Waverley Council

A meeting of **COUNCIL** will be held at the Waverley Council Chambers, Bondi Road, Bondi Junction at:

AGENDA

I-1202.2.1 PAGE 4 22 Isabella Street, Queens Park - Demolition of the existing building and construction of new dwelling with double garage and swimming pool (DA 40/2011)

PROPOSED FIRST FLOOR PLAN ANALYSIS

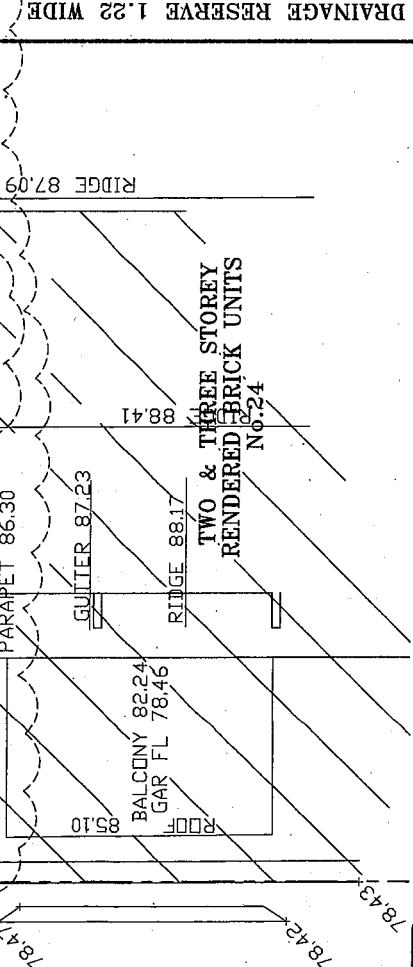
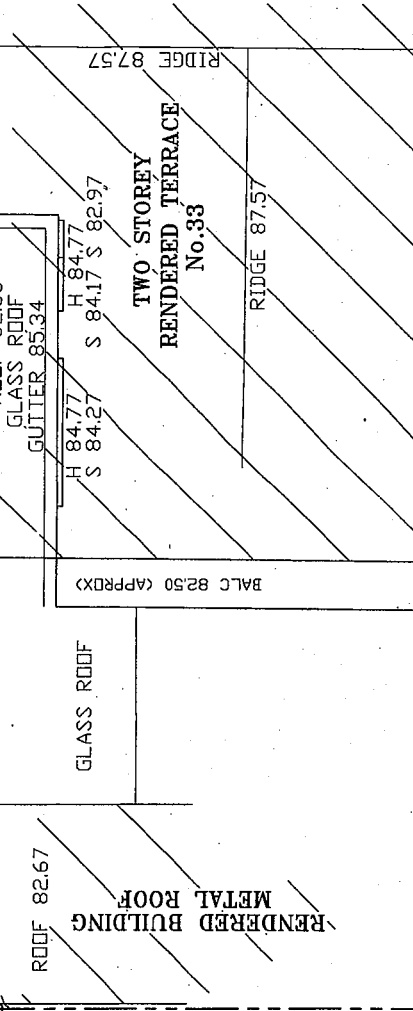
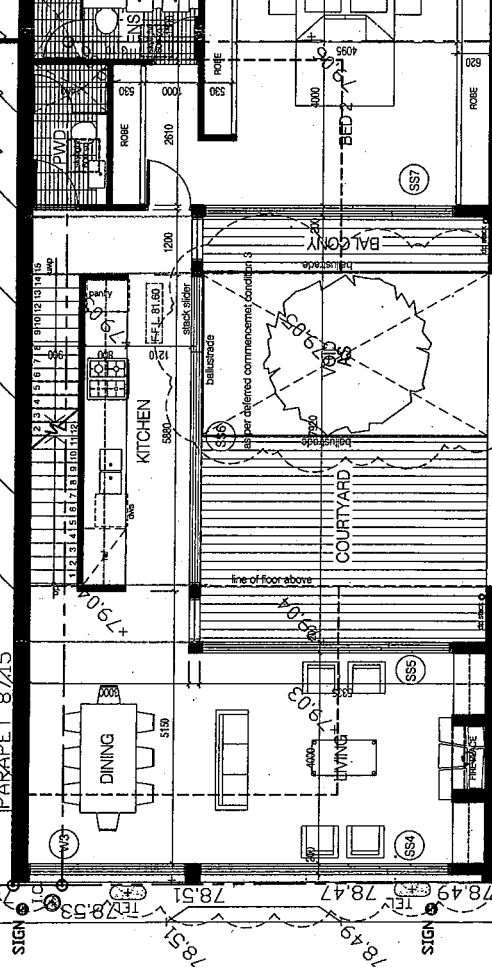
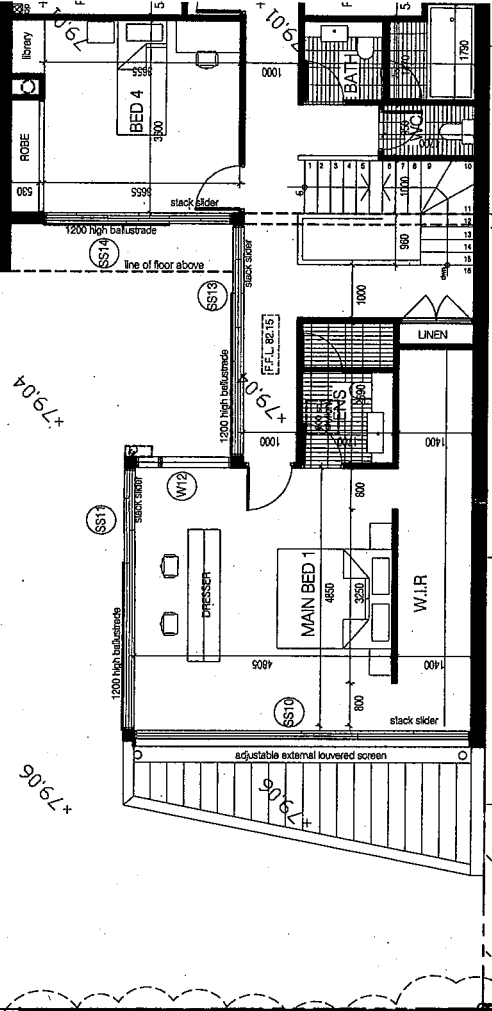
4. Courtyard openings to the first floor to be modified to windows.

The Panel considered that the Deferred Commencement Condition 4 may be modified by deleting the last two words "to windows", to allow design flexibility Condition 4 would read as "Courtyard openings to the first floor to be modified". The application is recommended for

- The openings to the first floor have been modified to windows where they don't adjoin a deck. The upper level deck has been modified to have an internal courtyard to increase the private open space for the property. This also allows for the infiltration of light to the lower courtyard through the void area.

PROPOSED SOUTHERN ELEVATION

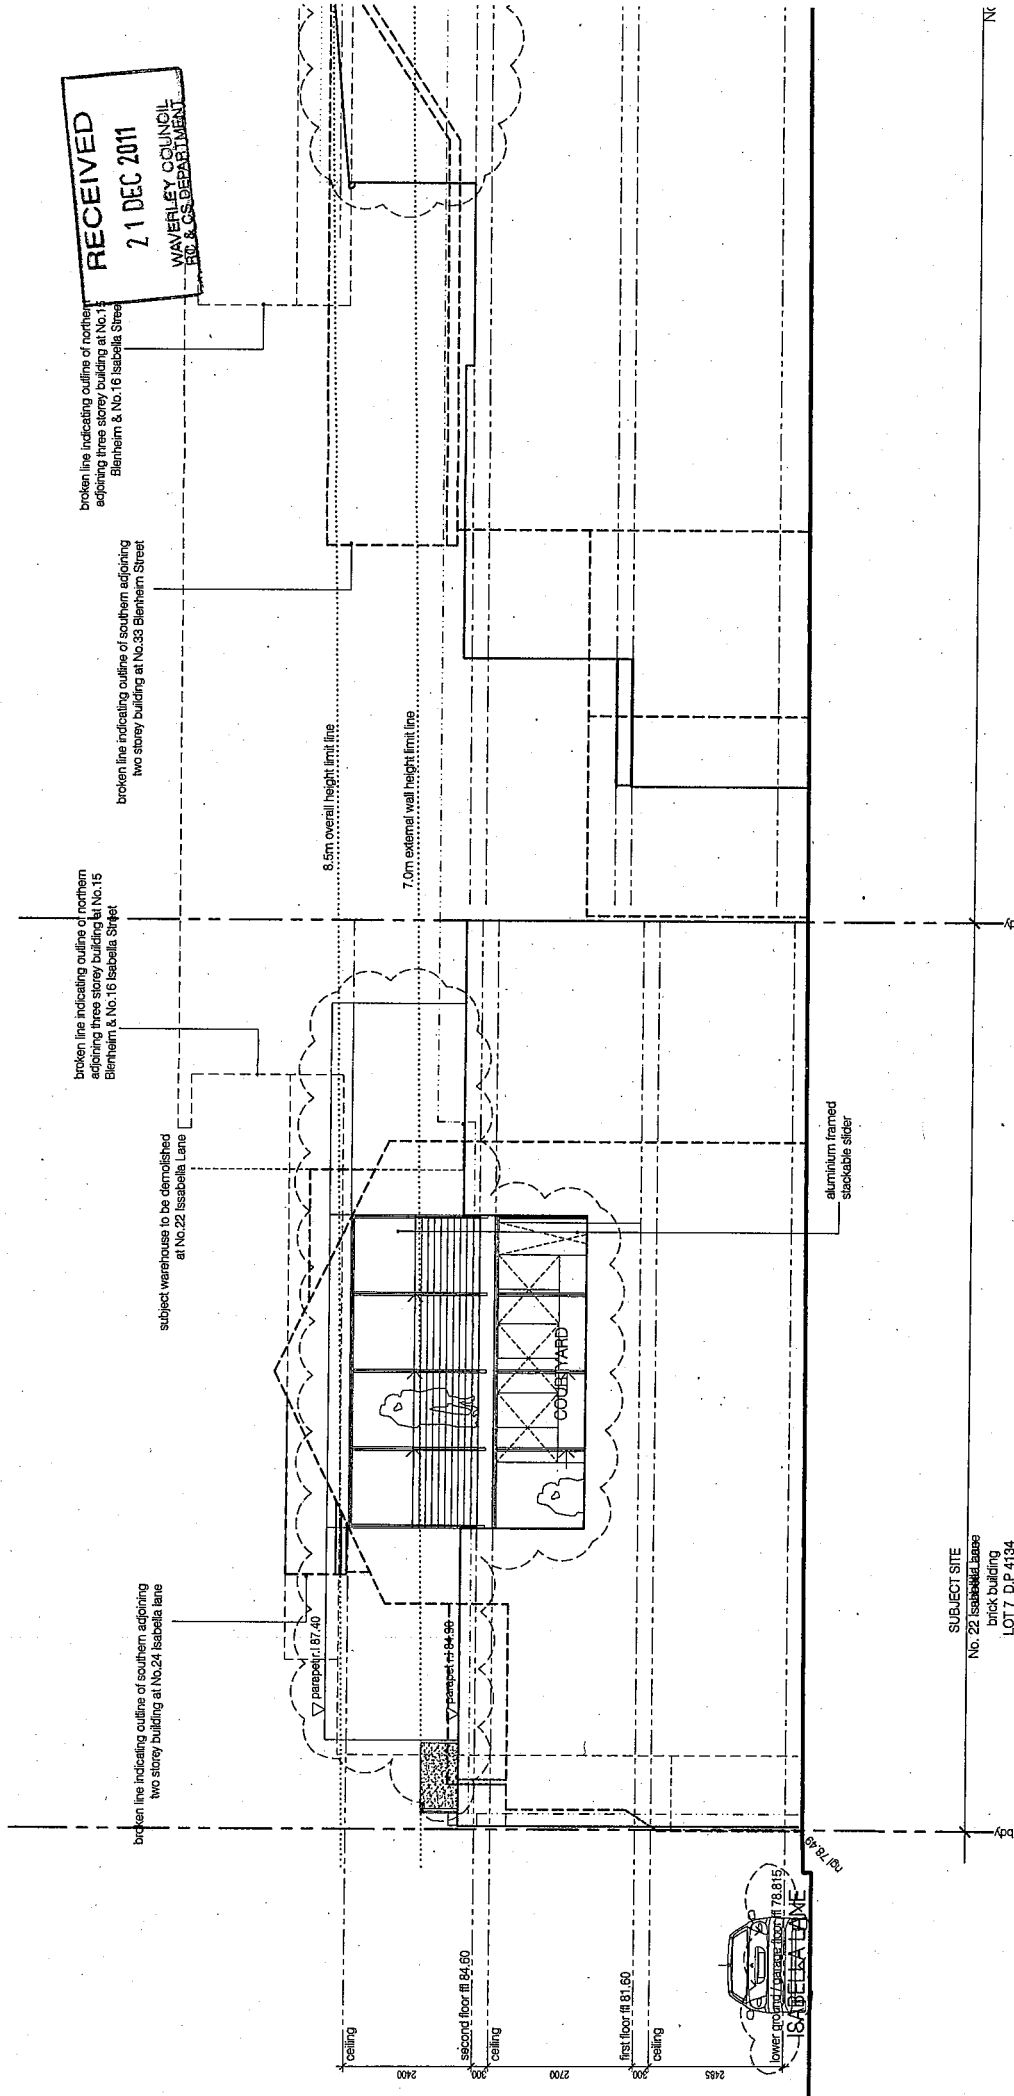
7. *The cladding system proposed to the street façade is not approved and it is to be modified to a high-quality face brick façade and the proportion of solid to void increased (particularly at the ground level). Materials and finishes of the street façade are to be to the satisfaction of Council's Heritage Architect.*

- The plans have been amended in accordance with the recommendation.
